TRANS/WP.29/GRPE/2000/8
9 March 2000

World Forum for Harmonization of Vehicle Regulations (WP.29)

PROPOSAL FOR DRAFT AMENDMENTS TO REGULATION No. 96
(Emissions of agricultural and forestry tractors)

Transmitted by the Expert from Italy

Model A

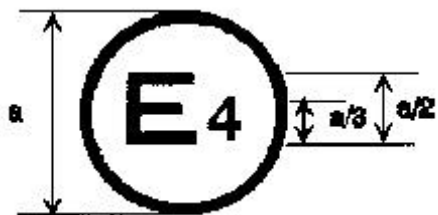
Annex 3, amend to read:

The above approval mark affixed to an engine shows that the engine type concerned has been approved in the Netherlands (E4) pursuant to Regulation No. 96 (according to the level corresponding to power band F) and under approval number 011857. The first two digits of the approval number indicate that Regulation No. 96 was in its amended form (series 01 of amendments) when the approval was granted.

Re. Annex 3,: the previous examples were not consistent with the present draft.
